**REMEDIATION SYSTEM EVALUATION**

**SELMA PRESSURE TREATING SUPERFUND SITE**  
**SELMA, CALIFORNIA**

Report of the Remediation System Evaluation,  
Site Visit Conducted at the Selma Pressure Treating Superfund Site  
November 7-8, 2001

Final Report Submitted to Region 9  
January 31, 2002

**FIGURE 1-1. SITE LAYOUT SHOWING THE MONITORING, EXTRACTION, AND RESIDENTIAL WELLS AND THE EXTENT OF CONTAMINATION IN THE SHALLOW, INTERMEDIATE, AND DEEP ZONES**

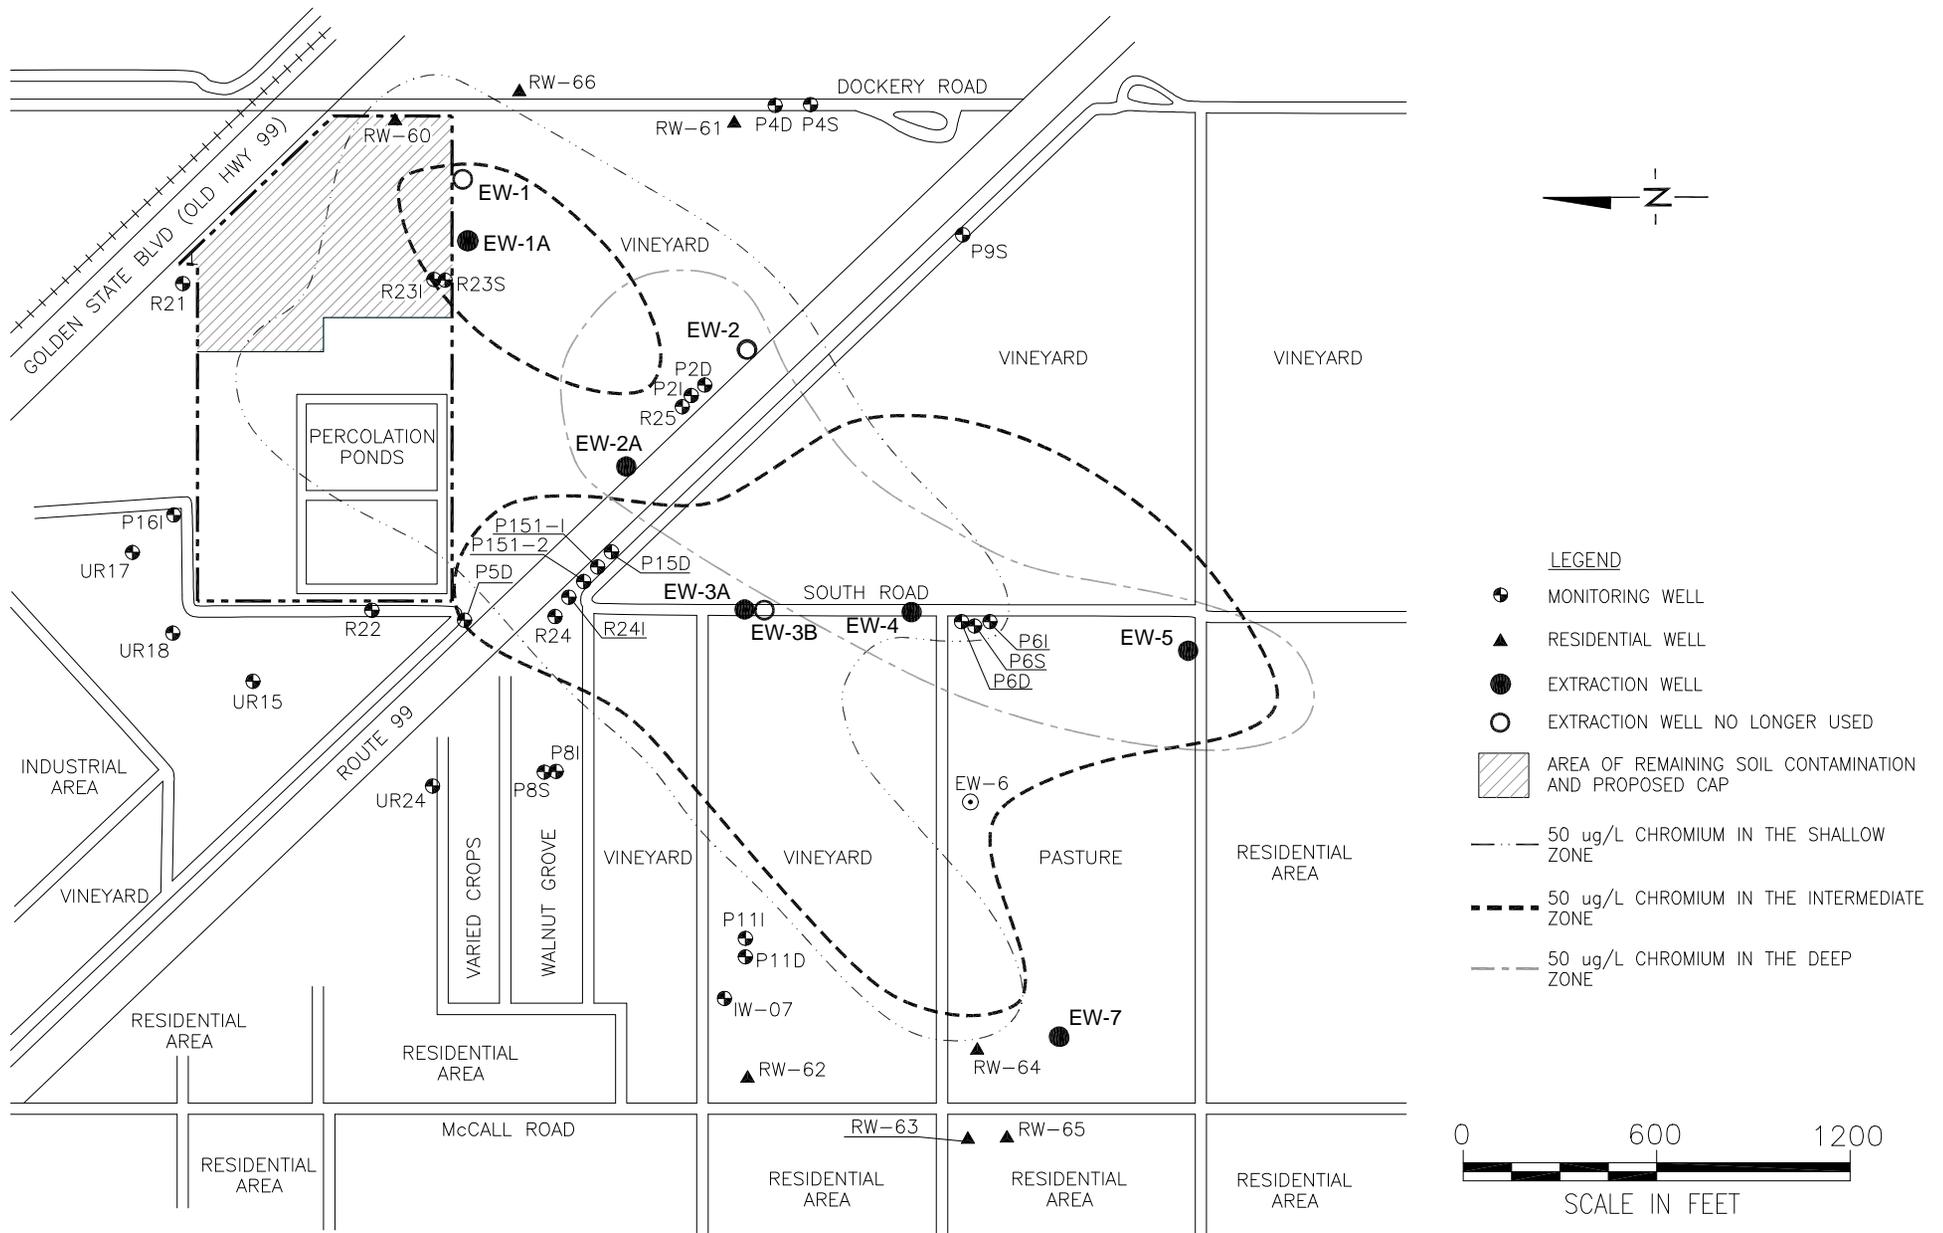
The groundwater plume, as illustrated in Figure 1-1, stretches from the former wood treating area to approximately 2,500 feet downgradient to the southwest and is approximately 1,000 feet wide. The plume extends approximately 50 feet below the water table, but due geologic heterogeneity (preferential pathways), the distribution is uneven. At approximately 1,600 feet downgradient from the source area, the plume splits into two separate, but parallel plumes as if an area of low hydraulic conductivity exists between them. Based on the July 2001 sampling event, the highest concentrations of chromium within the plume were found in monitoring well R23-I (6280 ug/L total chromium and 6020 ug/L hexavalent chromium).

As shown in Figure 1-1, R23 and R23I are adjacent to each other and are near former extraction well EW-1 and current extraction well EW-1a. Both extraction wells are screened between 45 and 60 feet below ground surface. The decrease of chromium in R23 and R23I may result from pumping water from EW-1 or EW-1a, treating it, and discharging the treated water through the percolation ponds. A possible explanation follows:

**FIGURE 4-1. SITE LAYOUT SHOWING THE APPROXIMATE LOCATIONS OF EXTRACTION WELLS IN THE PROPOSED EXTRACTION SYSTEM.**

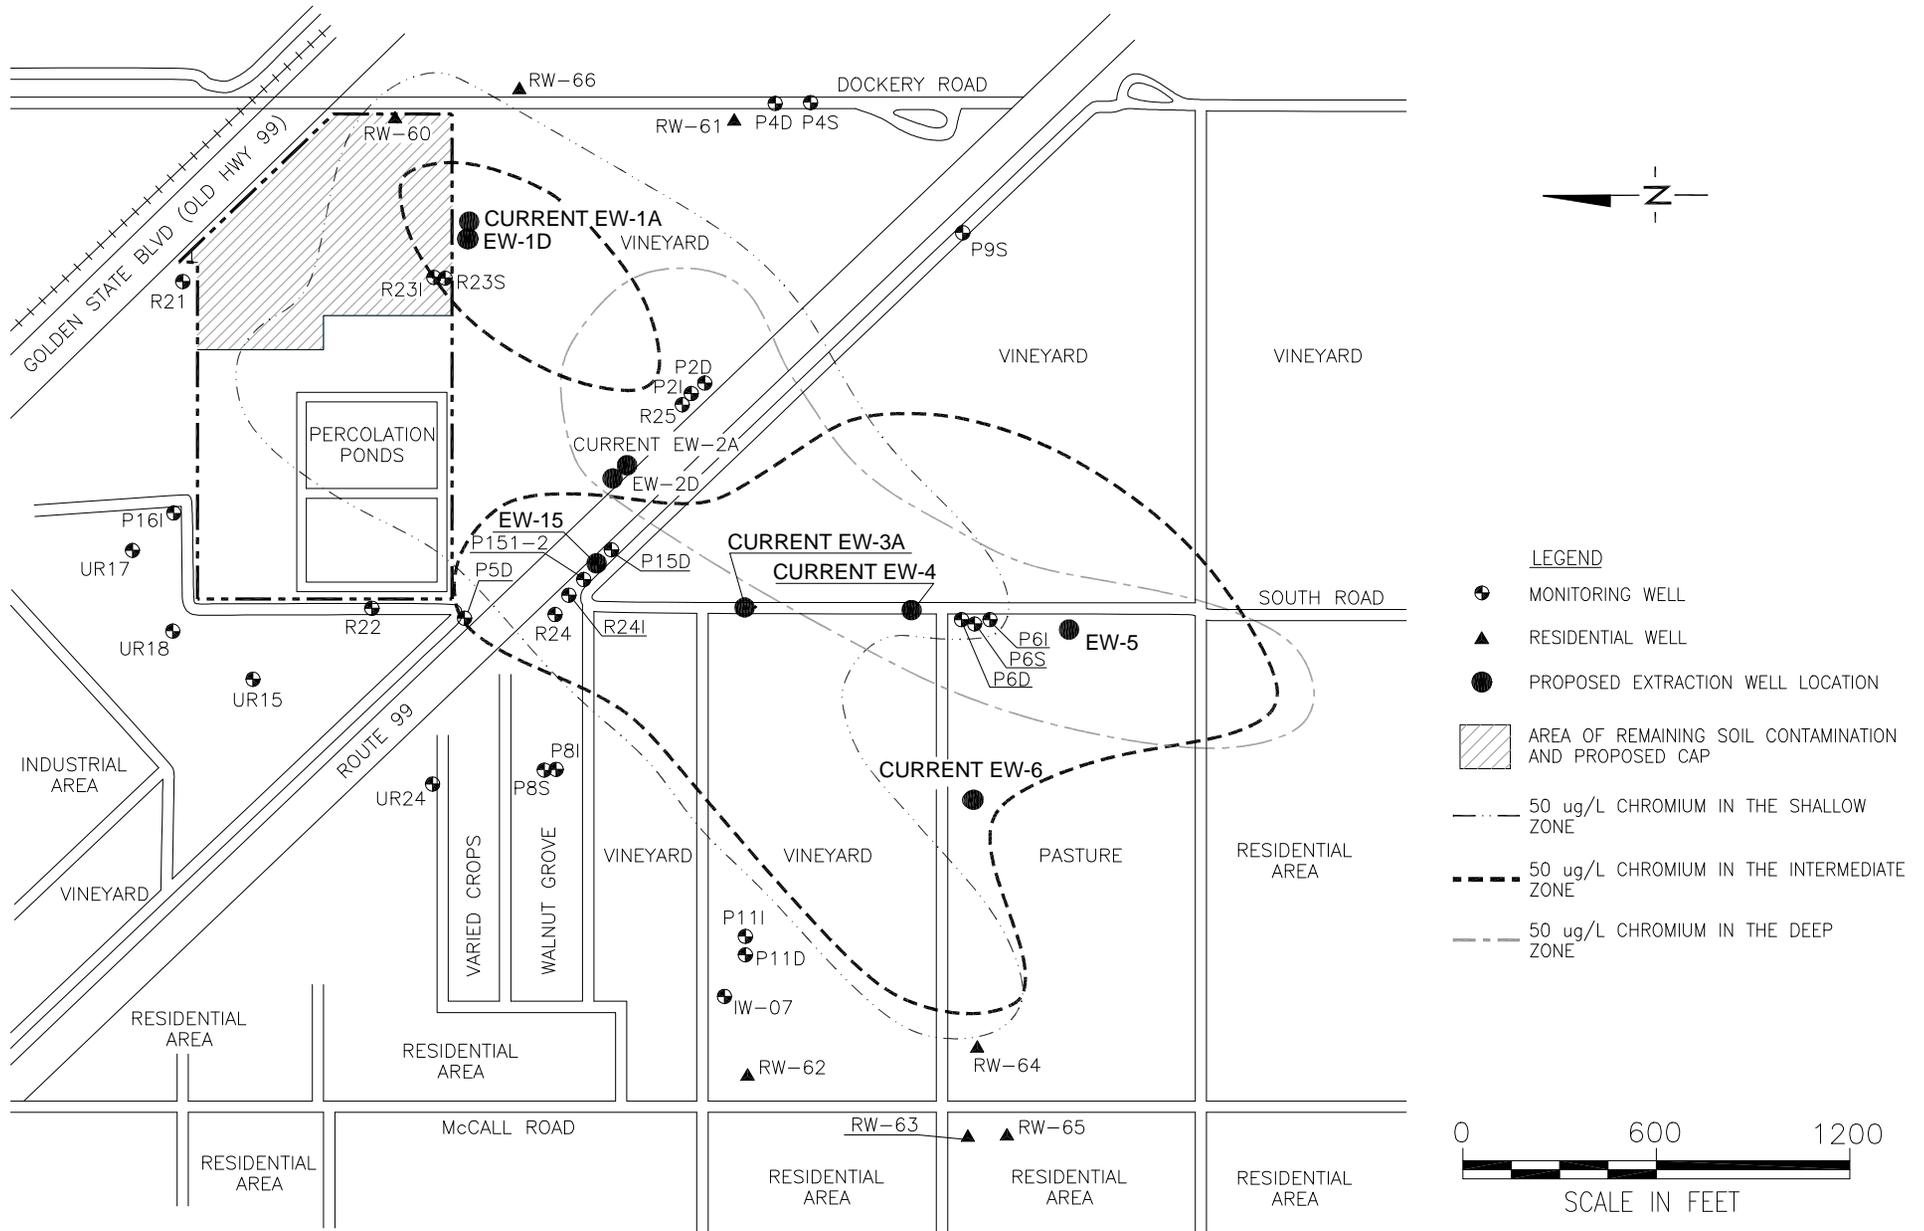
The site managers are planning to possibly shutdown EW-7 and relocate some of the other extraction wells to improve contaminant recovery. The proposed well relocations are depicted in Figure 4-1. Monitoring from EW-7 will likely continue to confirm shutdown of the well is appropriate.

The site managers are considering relocating some of the extraction wells to improve capture and simultaneously increase contaminant recovery rates. The proposed relocations are noted in Figure 4-1. Although these locations make sense conceptually, verifying these proposed locations and screening intervals with the model would be beneficial.

**FIGURE 6-1. MODEL SIMULATION FROM THE ORIGINAL CAPTURE ZONE ANALYSIS SUGGESTING CAPTURE OF THE PLUME IN THE ABSENCE OF RECHARGE FROM THE PERCOLATION PONDS**

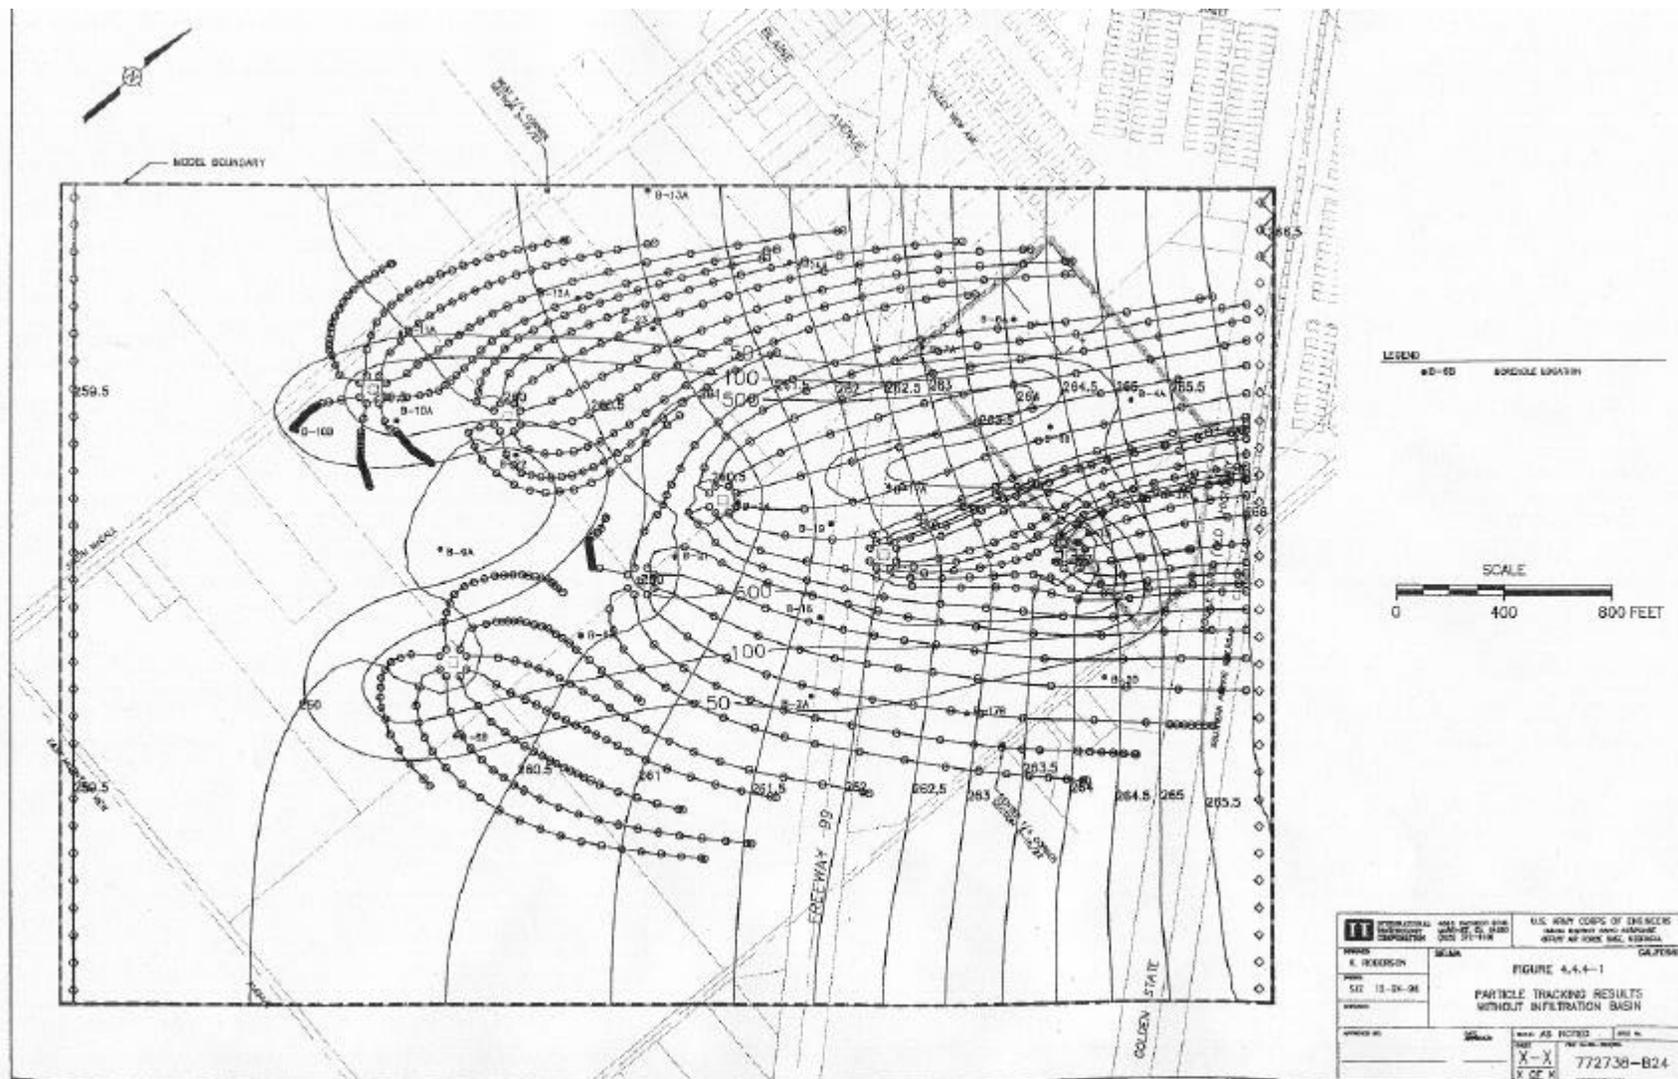
On a more general note, a capture zone analysis should demonstrate that water flow through the impacted area is captured by the extraction wells. According to the particle tracking from the existing model shown in Figure 6-1, particles in the background flow field (upgradient of the extraction wells) traveled at approximately 200 to 300 feet per year. Removing the effect of porosity, this translates to a Darcy velocity of approximately 100 feet per year. The model domain is 3,000 feet wide, and it appears from Figure 6-1 that the extraction system capture zone is also approximately 3,000 feet wide. The thickness of the three layers varied across the domain, but on average, it appears that a saturated thickness of 100 feet is fairly representative. Assuming that half of the formation has a significantly lower hydraulic conductivity than the other portions, the majority of groundwater flow of 200 to 300 feet per year may be occurring only through effectively half of the cross-sectional area of the model domain and flow through other portions may be significantly less. Following this assumption about the formation, the above Darcy velocity should be reduced by half from 100 feet per year to 50 feet per year. Thus, groundwater flow into the model domain and to be captured by the extraction system is approximately

This simple calculation, although based on crude estimates, suggests that the extraction system extracts approximately the same amount of groundwater as is flowing from upgradient. If the recharge provided by the percolation ponds is included, then the width of the capture zone decreases, which is consistent with another model simulation (depicted in Figure 6-2) conducted as part of the original capture zone analysis. The degree to which the capture zone narrows, however, will be dependent on the amount of recharge provided by the percolation ponds or by natural recharge. The amount of recharge from the ponds likely varies with the seasons because more water in the ponds will evaporate in the summer than in the winter, and the amount of natural recharge will also vary based on the seasons—potential increases may occur in the winter with the rainy season or in the summer during irrigation. The recharge rate through the percolation ponds that was used in the original capture zone analysis should be reviewed and the model should be used to determine how sensitive capture is to that recharge rate. In addition, estimates of the amount of recharge should be obtained. This could, perhaps, be accomplished by taking the discharge rate from the treatment plant and accounting for potential evaporation. If the potential evaporation is not known, then it could be measured through simple studies with evaporation pans.

**FIGURE 6-2. MODEL SIMULATION FROM THE ORIGINAL CAPTURE ZONE ANALYSIS SUGGESTING CAPTURE OF THE PLUME IN THE PRESENCE OF RECHARGE FROM THE PERCOLATION PONDS**

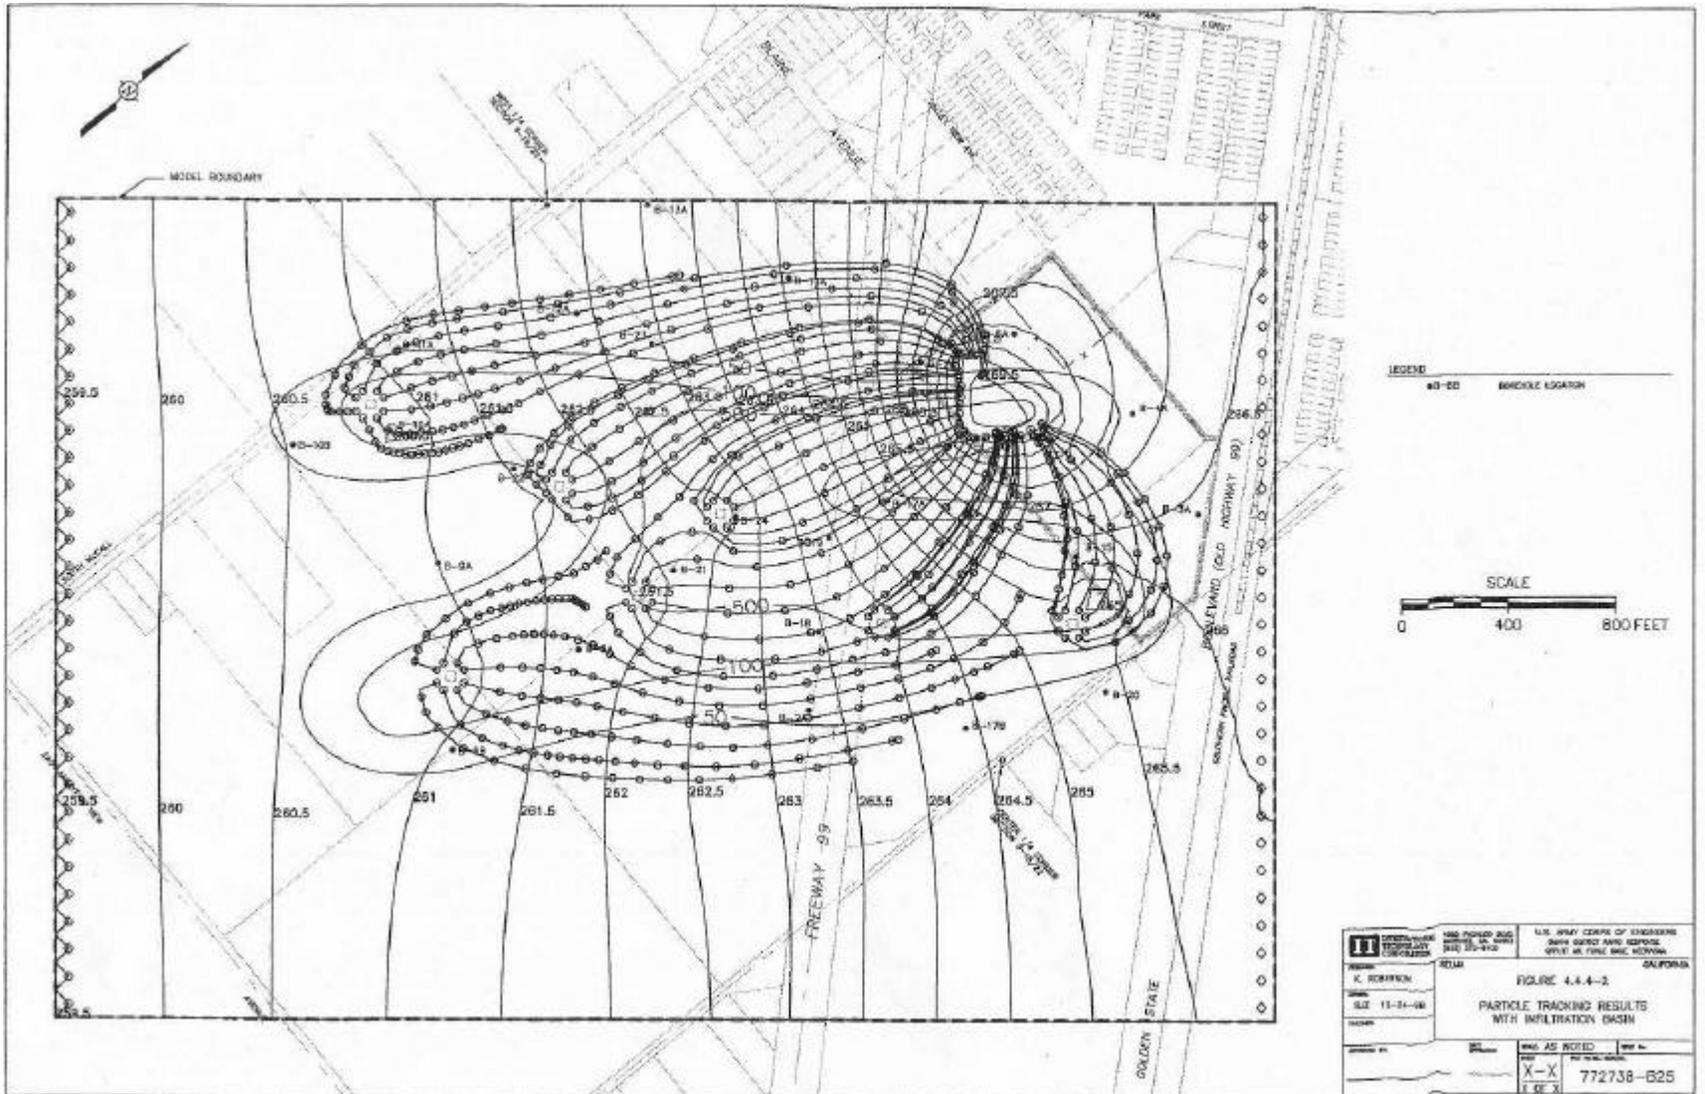
In extracting groundwater, EW-1 and/or EW-1a pull water from surrounding horizontal and vertical areas. A capture zone analysis conducted as part of the system design (later discussed in Section 6.1.1.3 and depicted in Figure 6-2) indicates that treated water from the percolation ponds was likely captured by EW-1. Because EW-1a is located closer to the ponds than the former EW-1, EW-1a also likely captures treated water from the percolation ponds. As this treated water migrates from the shallow zone below the percolation ponds toward EW-1 or EW-1a, it may serve to dilute the water sampled in R23, a relatively shallow monitoring well. However, because R23I is deeper than R23, the treated water from the percolation ponds may not reach it. Rather, contaminated water from other surrounding areas may pass through R23I as it travels toward the extraction well resulting in an increase in chromium concentrations in R23I.
